BAR Meeting
December 17, 2008

ISSUE: Alterations and Signage

APPLICANT: City of Alexandria (Patrice McAuliffe, Agent)

LOCATION: 134 North Royal Street (Gadsby's Tavern)

3 GUARDRAIL SECTION
 G003 1/2" = 1'-0"

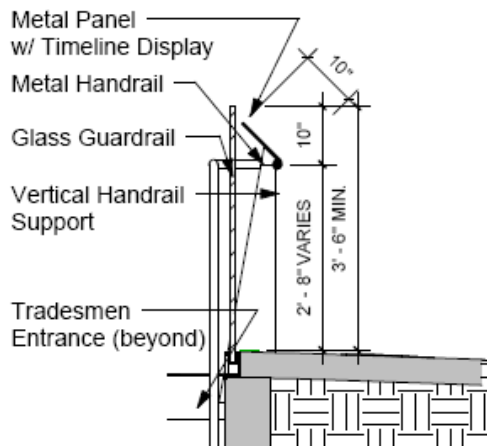
- C-4 The new handrails must comply with USBC for a minimum/maximum height of 30 to 34 inches. The ends must extend 12" beyond the top and bottom risers. The handgrip position must not be more that 2-1/4" in cross-sectional dimension, or the shape must provide an equivalent gripping surface. The handgrip portion must have a smooth surface with no sharp corners. The space between the wall and handrail must not be less that 1-1/2".

- C-5 Handrails must comply with USBC 1009.10.
- C-6 The accessible ramp must comply with the requirements of USBC 1010.1. The front approach to the exterior door (which is on the pull side) must comply with the landing requirements of USBC 1010.6. Handrails must comply with USBC 1010.8

1 PUBLIC SPACE LIGHTING PLAN
AL100 1/4" = 1'-0"

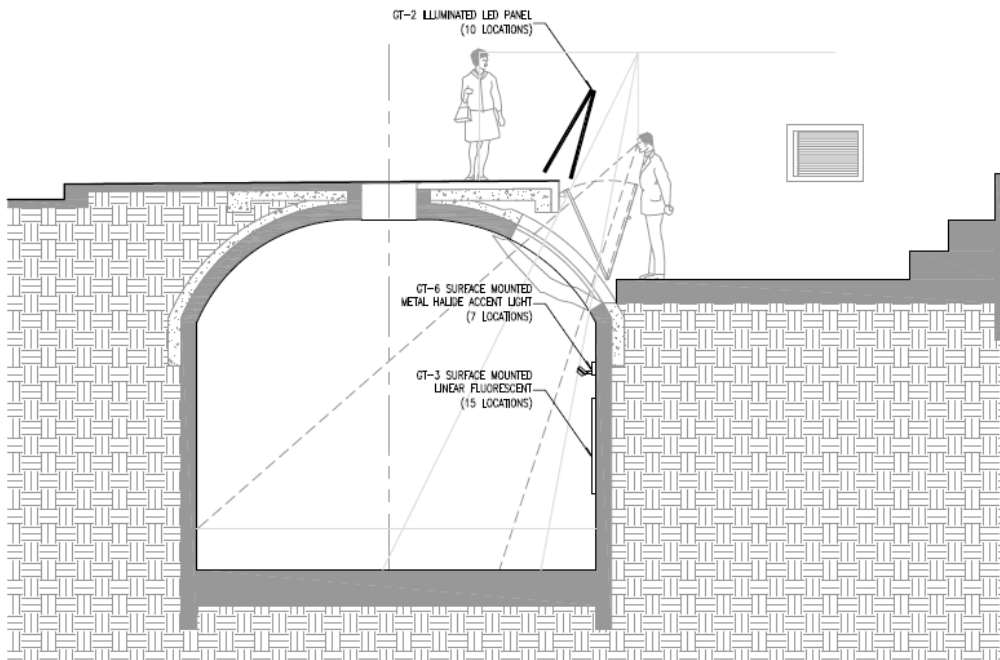
2. That the applicant and their design team will work with Historic Preservation Planning staff to modify the lighting program to reduce the lighting levels and impacts of the proposed lighting design on the Right-of-Way and adjacent buildings, and that the implemented lighting design will be approved by the Historic Preservation staff prior to the project's final permit inspections.

Per Staff's request, the applicant has provided an existing and proposed photometric study of the site (see page 23). The data generated reflects the lighting design goals, which is to maintain the Ice Well as the focal point, while instituting a uniform and safe experience for patrons in and around the site. Staff is concerned with the current lighting design, the intensity of the lighting shown, and corresponding light spillage beyond the ice well into the surrounding public Right-of-Way (ROW). The lighting levels shown are the maximum levels that are possible with the proposed fixtures and are much higher than Staff believes is appropriate at this location. Staff recommends a reduction in lighting levels and corresponding impacts to pedestrians, drivers and the adjacent community. Such a reduction can be achieved though encouraging illumination levels of 0.6 footcandles or below in the public ROW. Staff understands from the applicant that the light fixtures proposed can be adjusted to emit lower levels of light. As this is a complex project where lighting is a key design element, Staff recommends that the applicant work with Staff to modify the lighting levels to reduce the project's lighting level photometric calculations and approve the final installed design prior to the project's final permit inspections.
